ADDENDUM NUMBER 02 TO THE BID DOCUMENTS

**BID DOCUMENT: 17/18 MB7
I21-35617 - Organic Farm Classrooms
College of Marin – Indian Valley Campus**

Addendum Date: 23 February 2018

A0.20

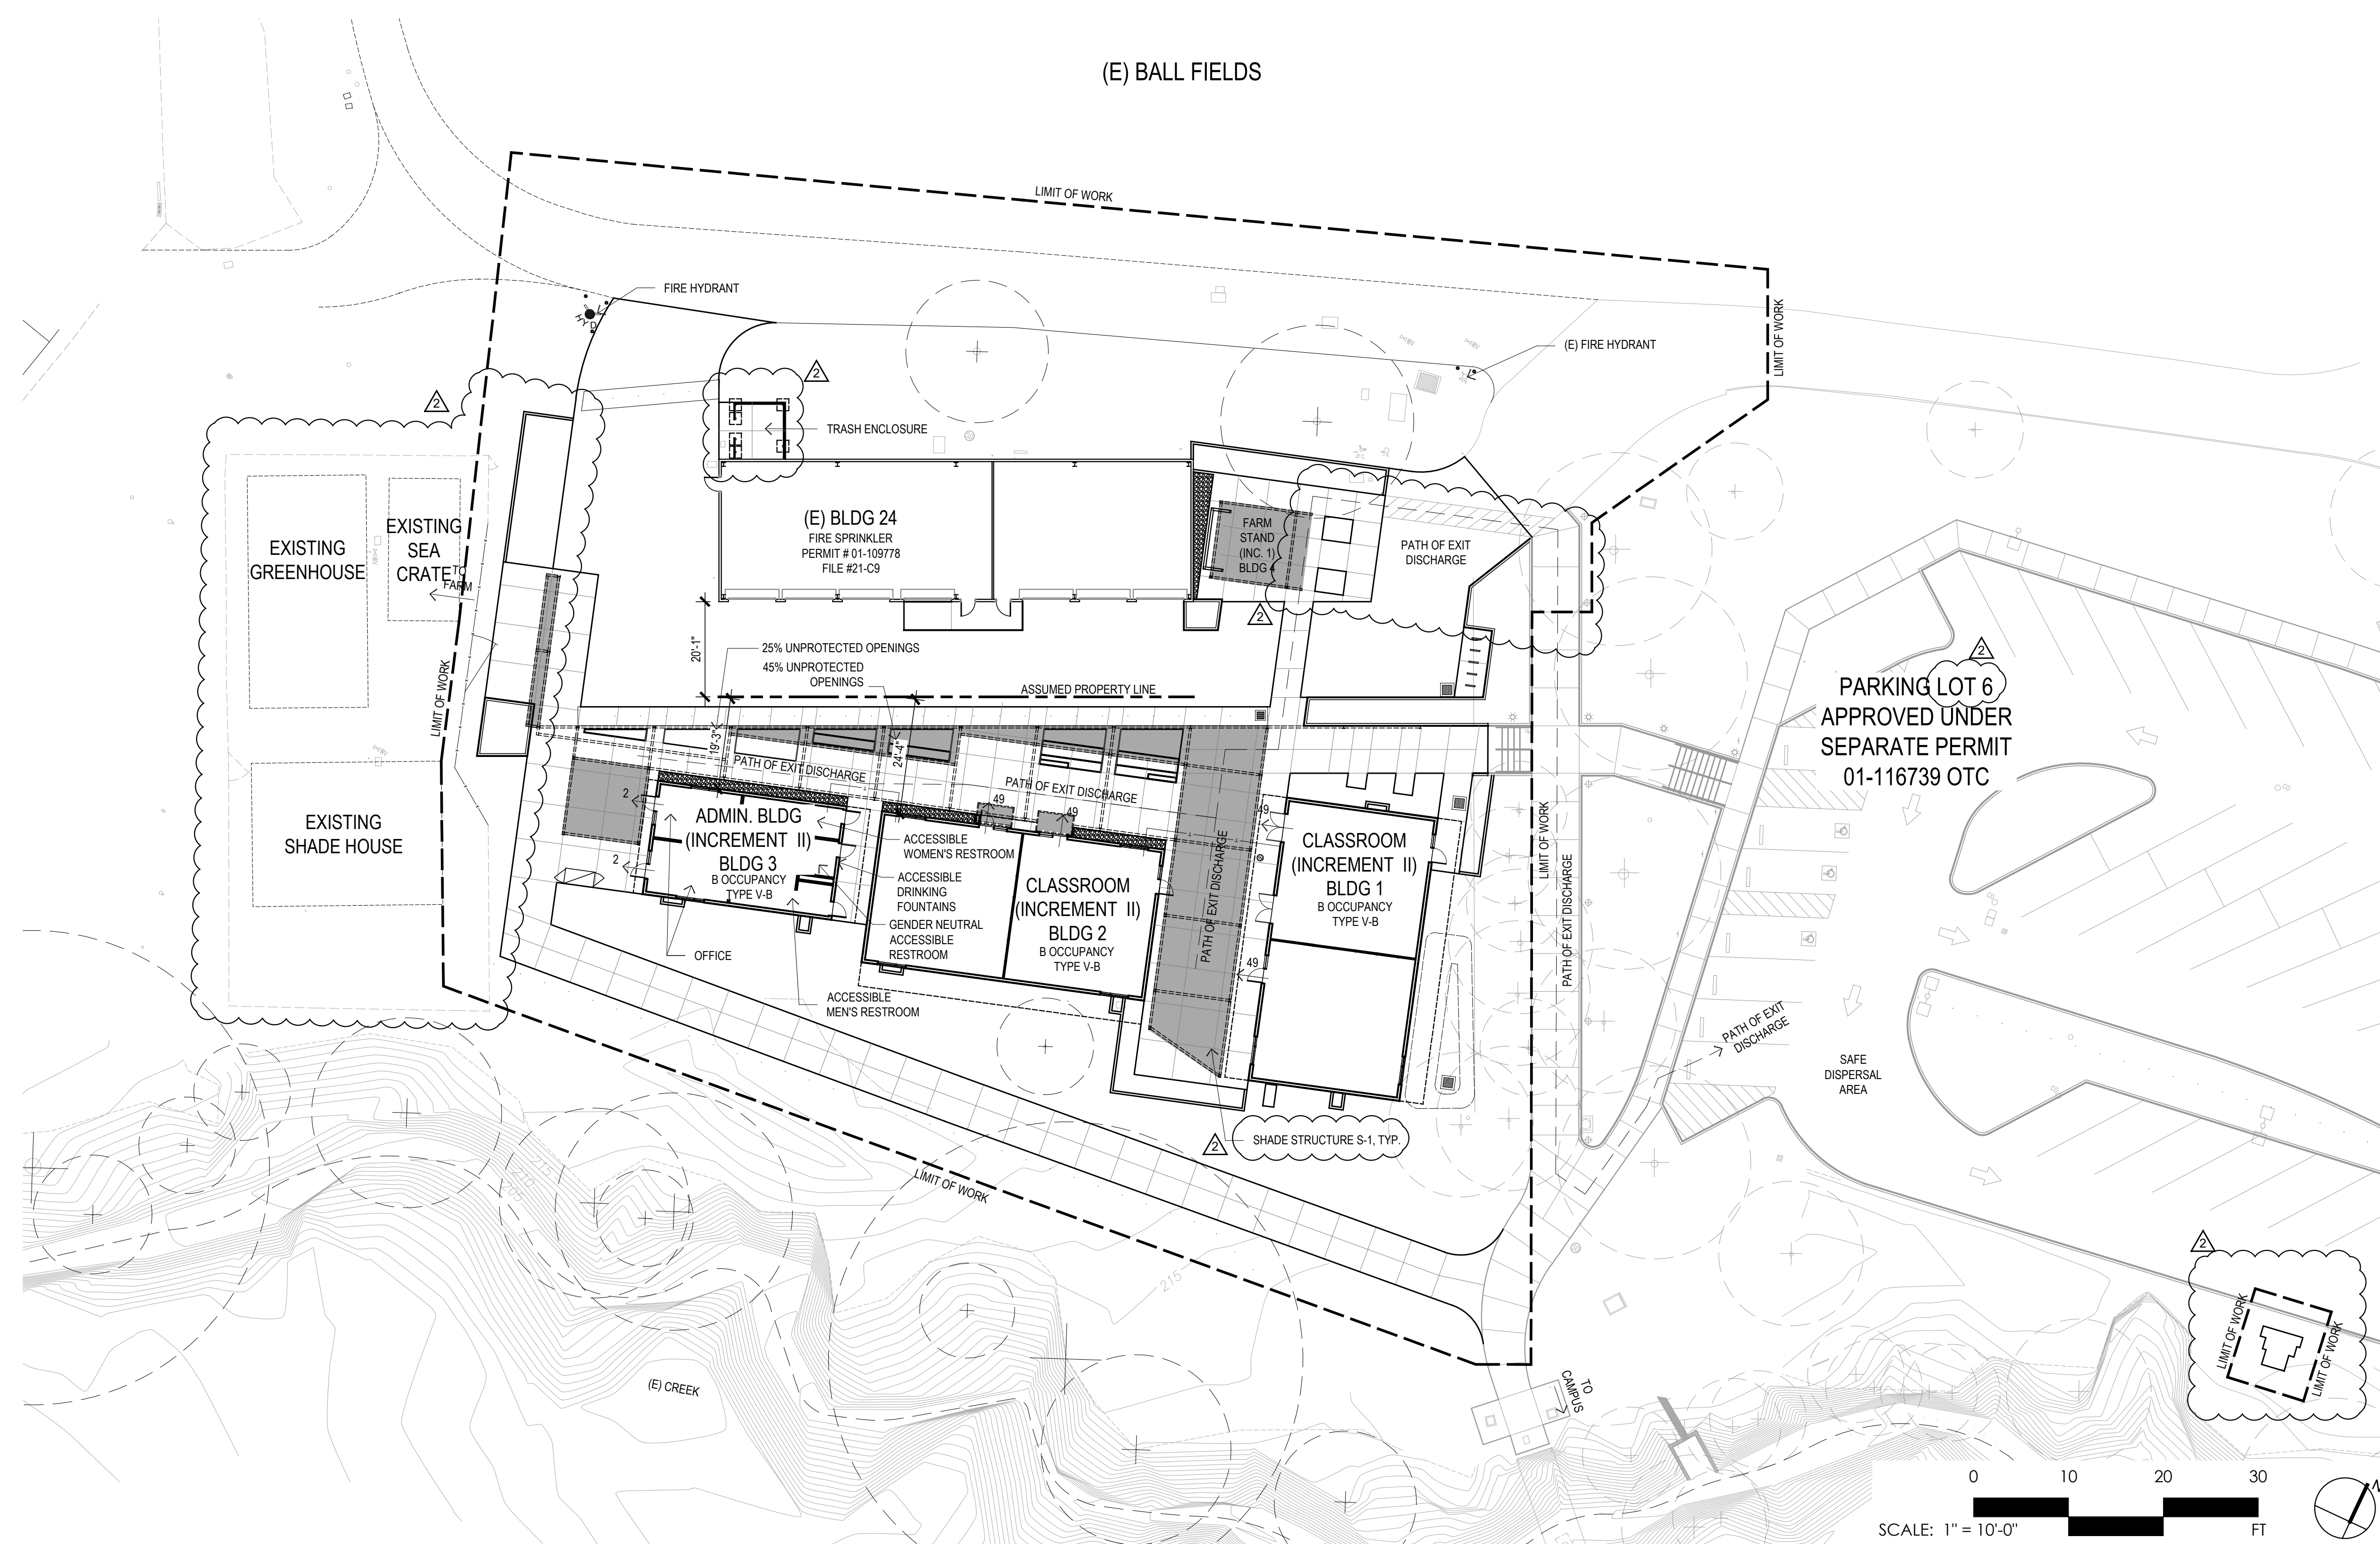
- Updated area of Scope of Work, existing Greenhouse, Shade Structure, Sea Crate and fencing to remain.
- Updated area of Scope of Work, tie into existing substation below.
- Updated trash enclosure.
- Updated path of exit discharge.

A0.40

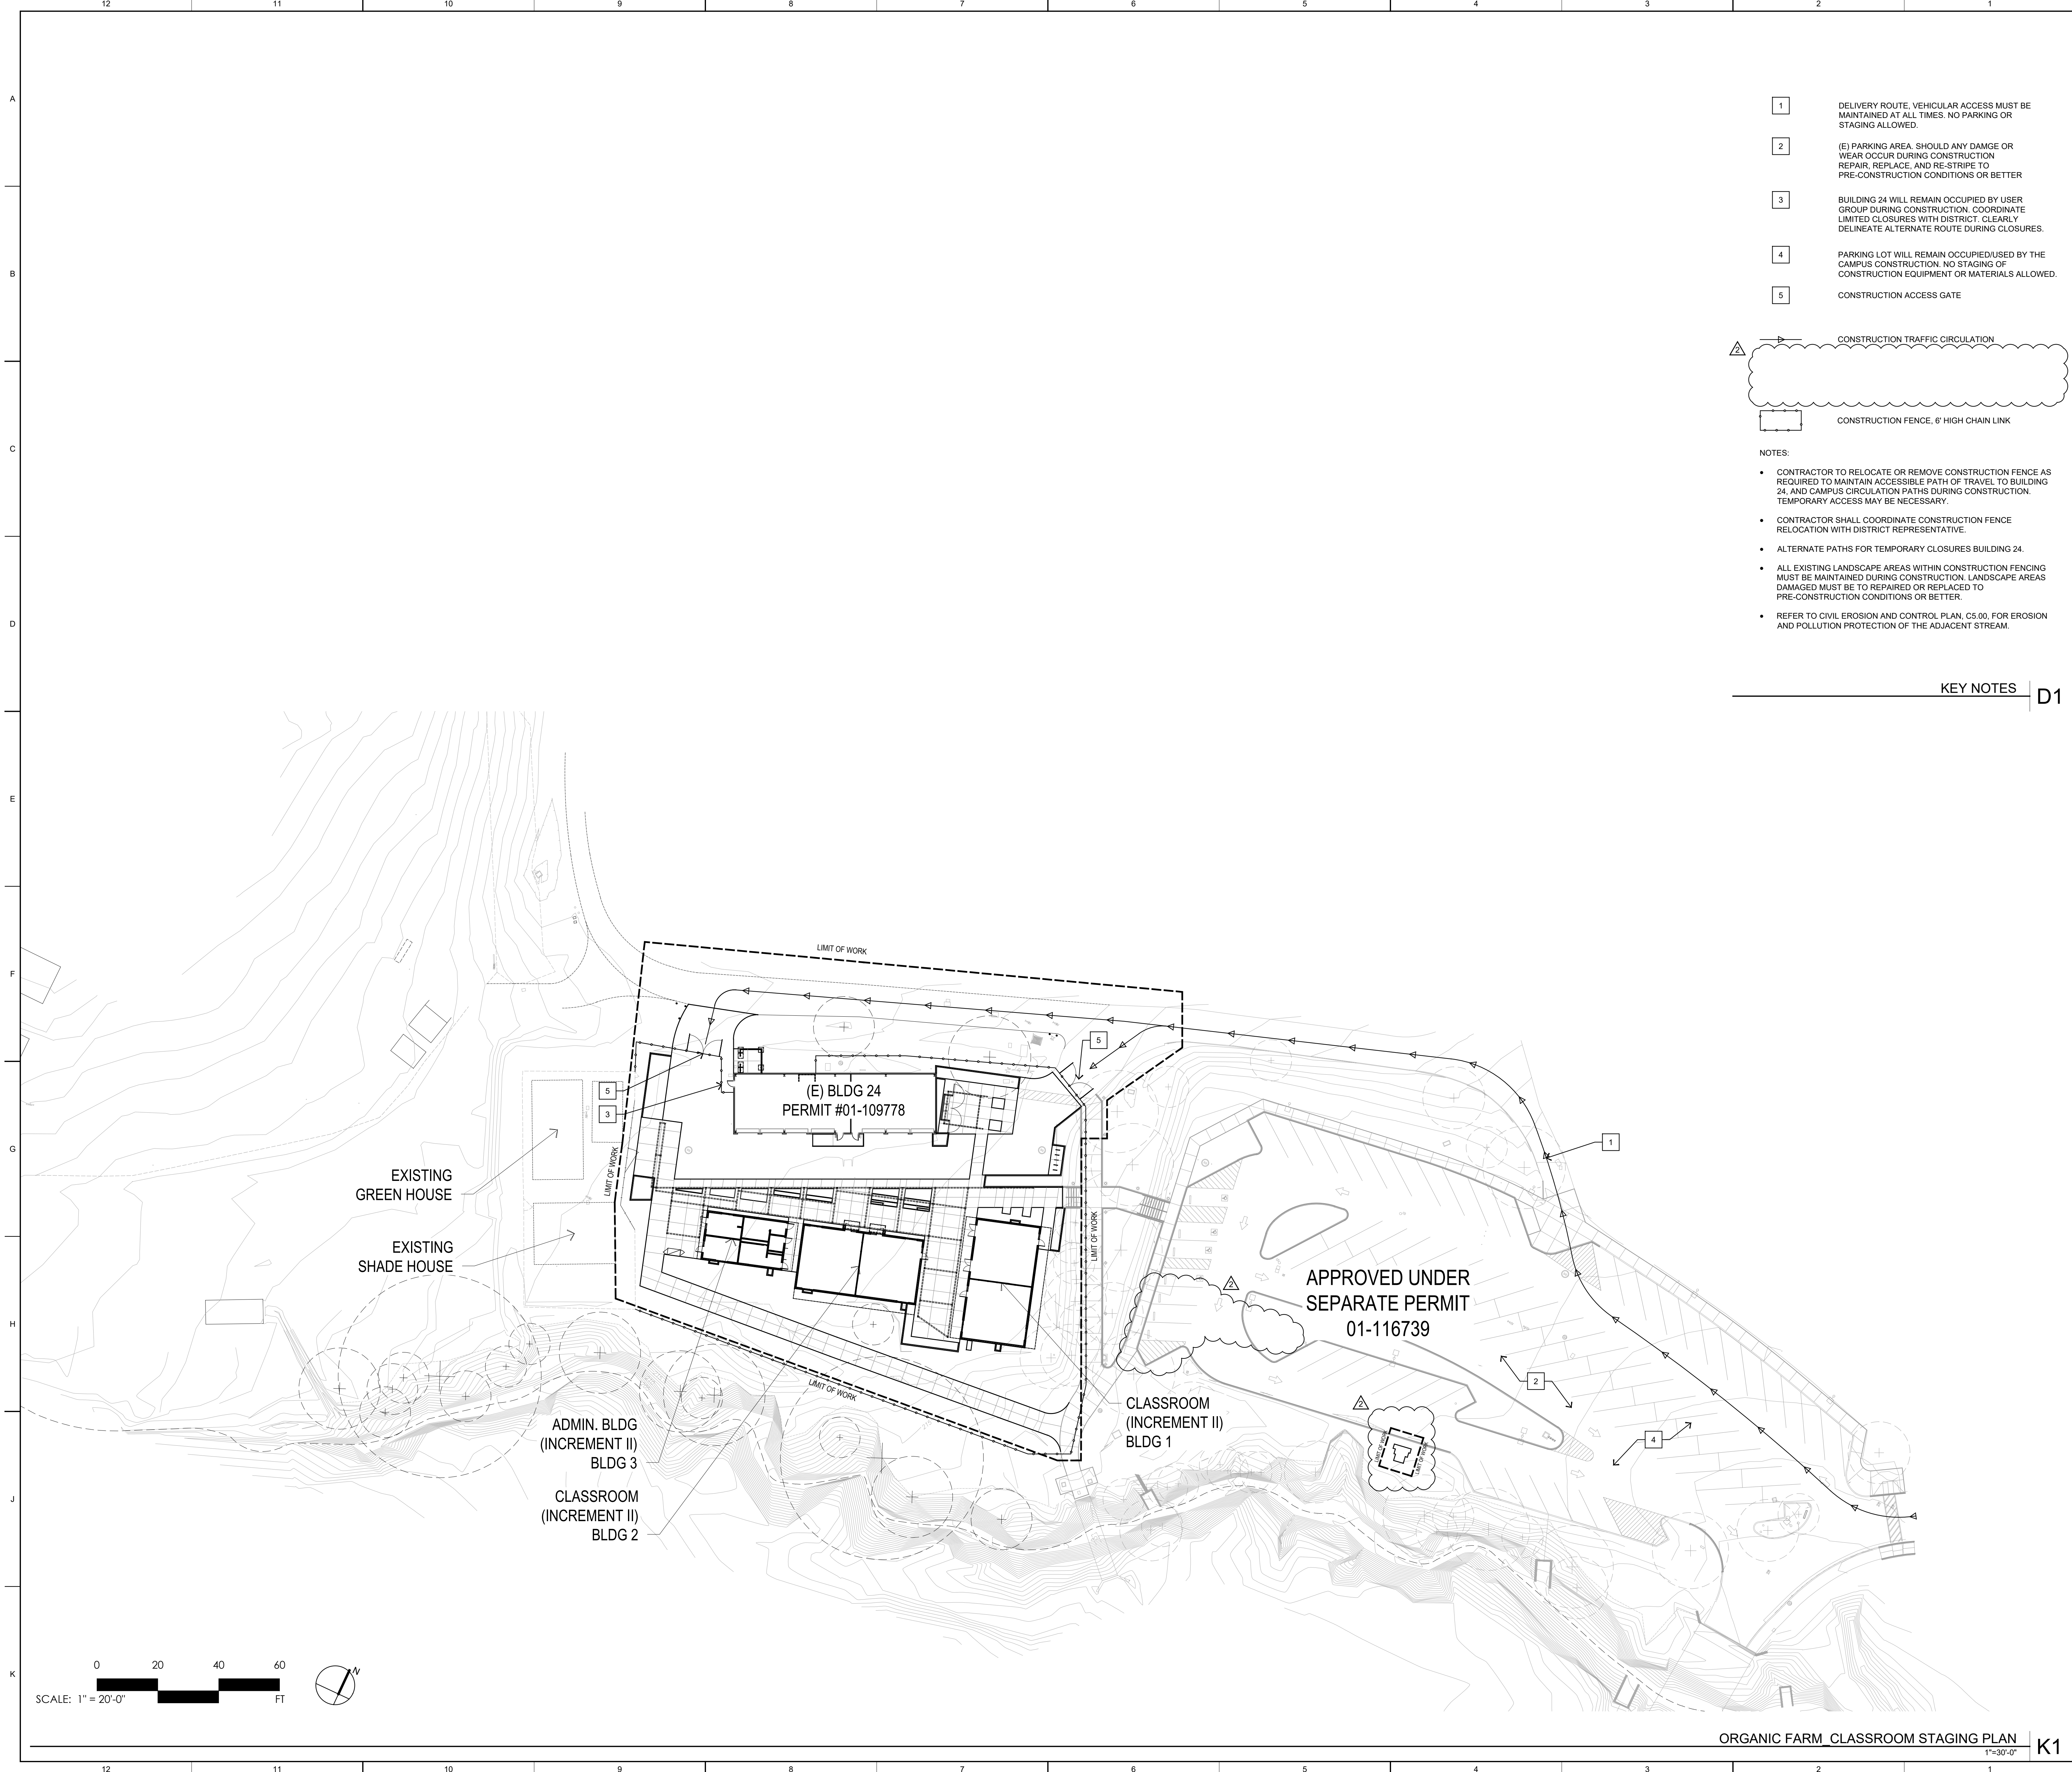
- Removal of Trailer Staging Area.

A1.00

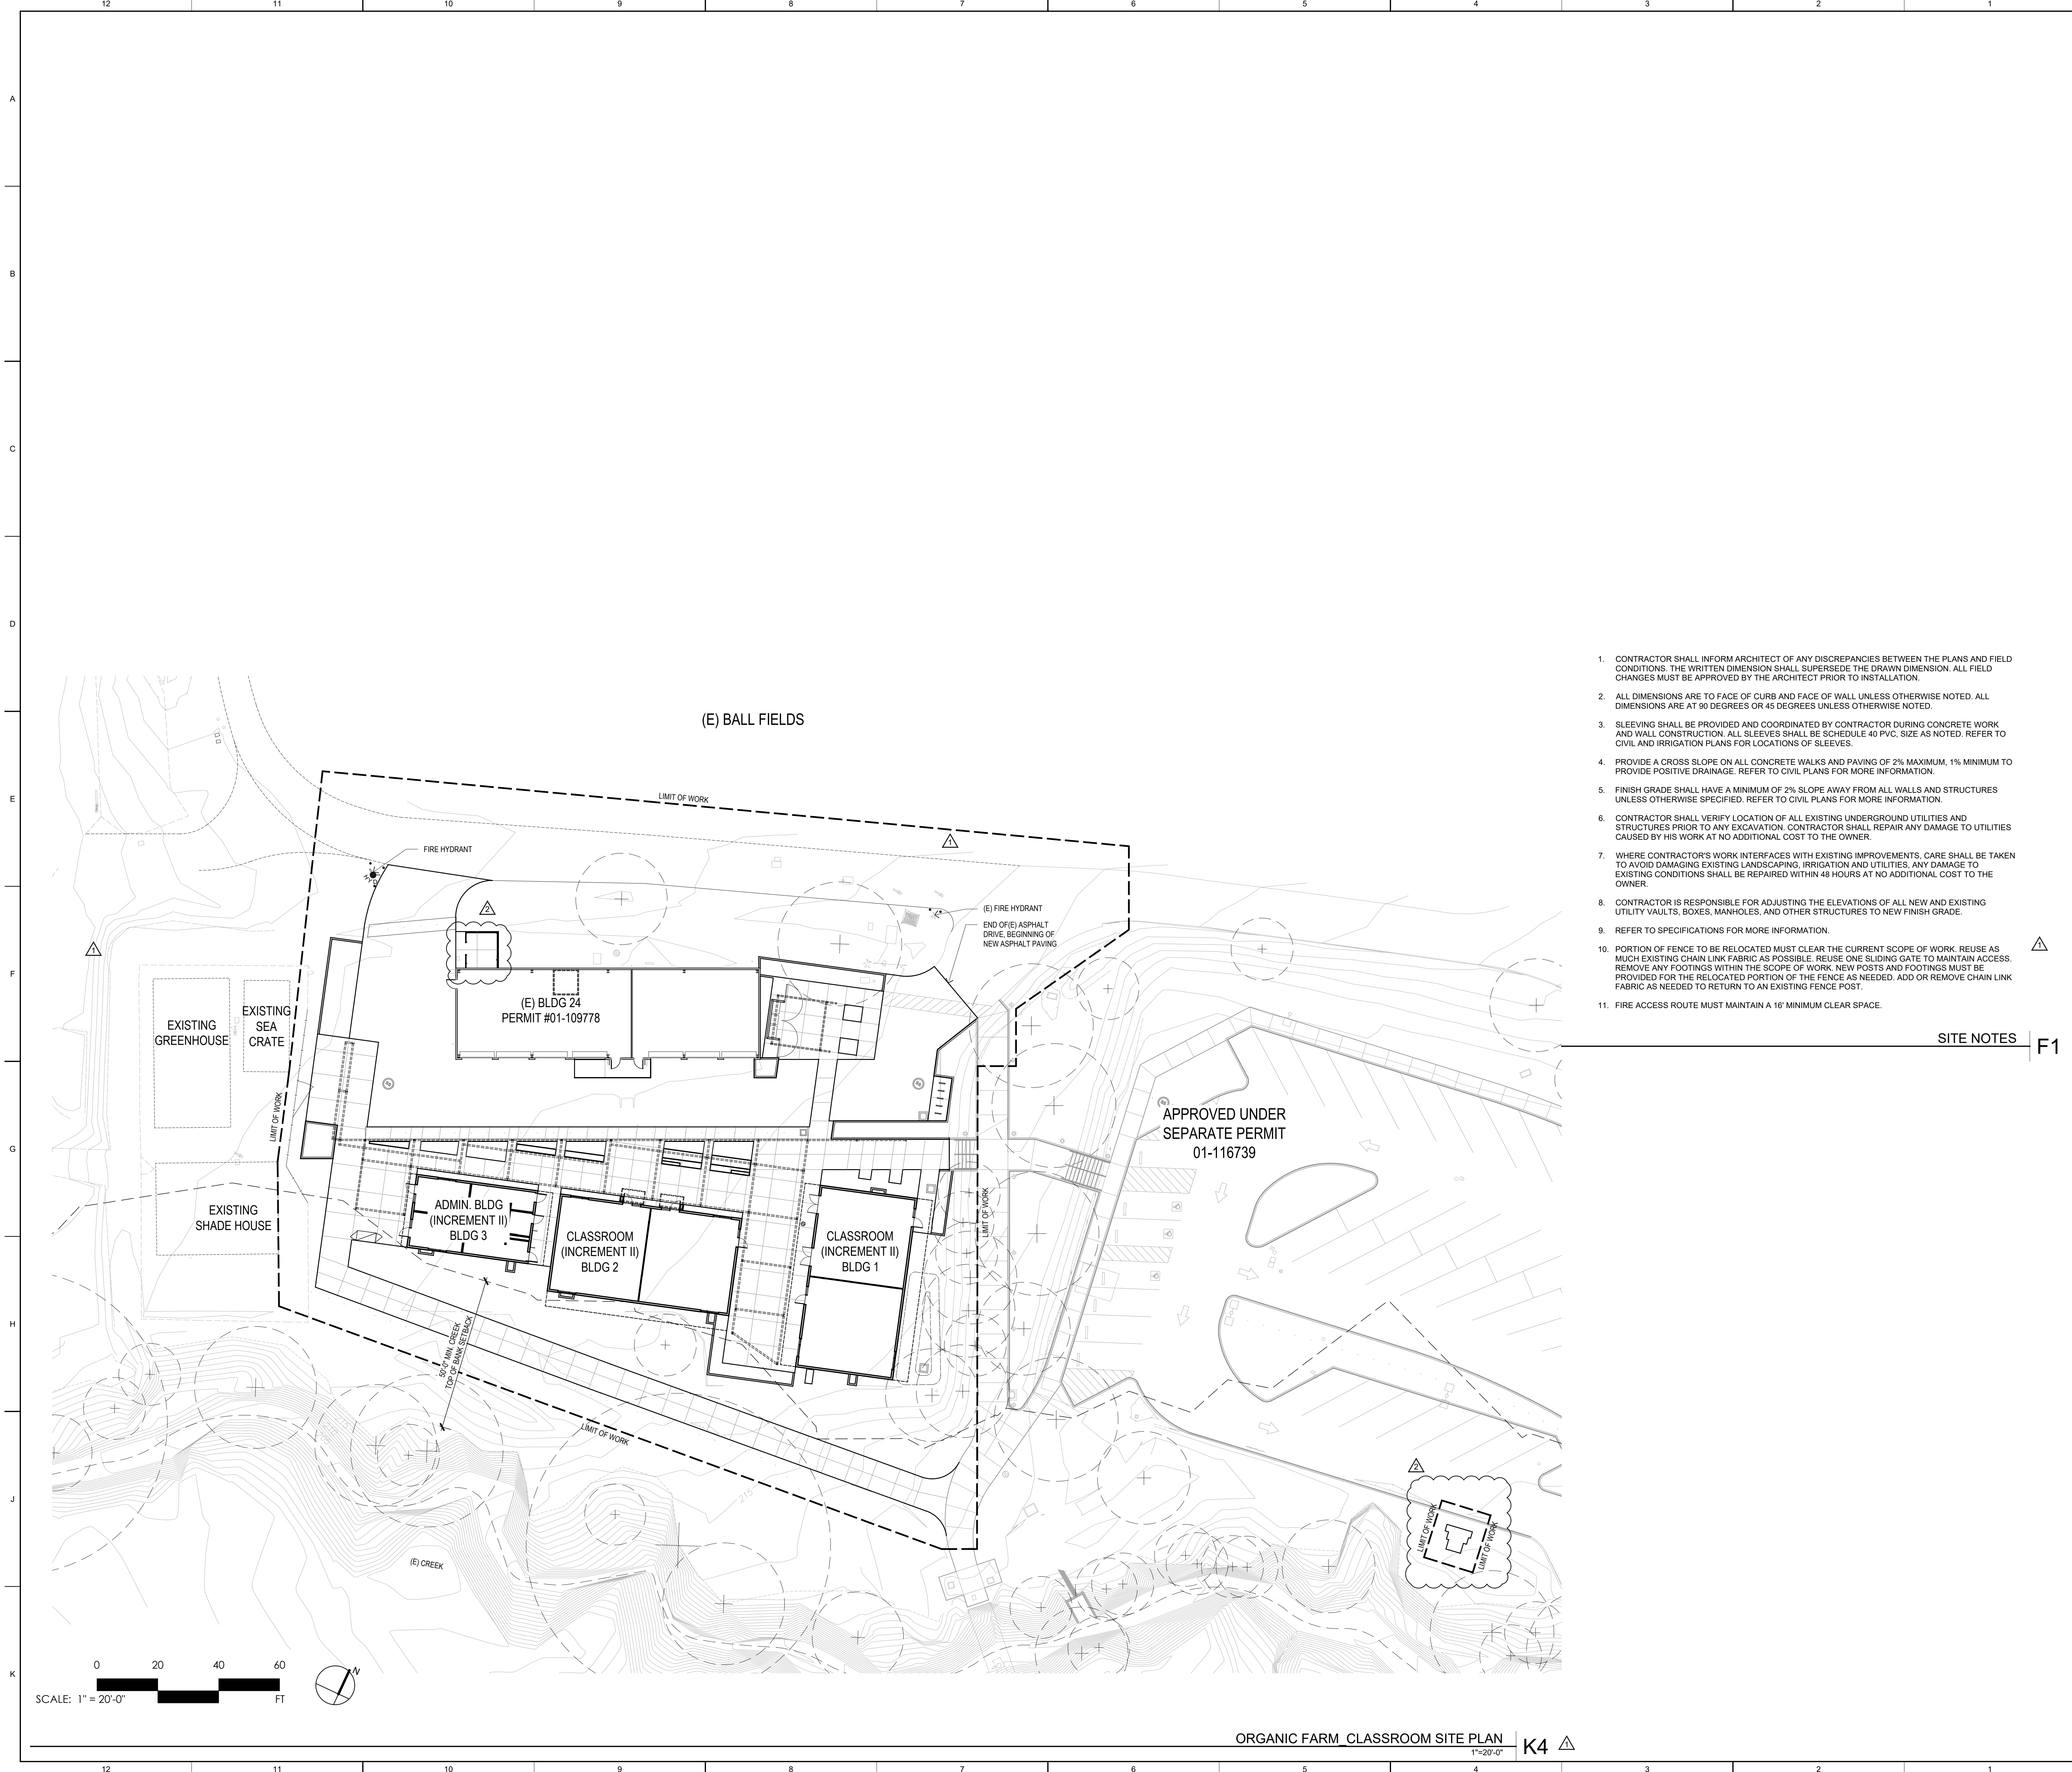
- Revised trash enclosure.
- Updated area of Scope of Work, tie into existing substation below.
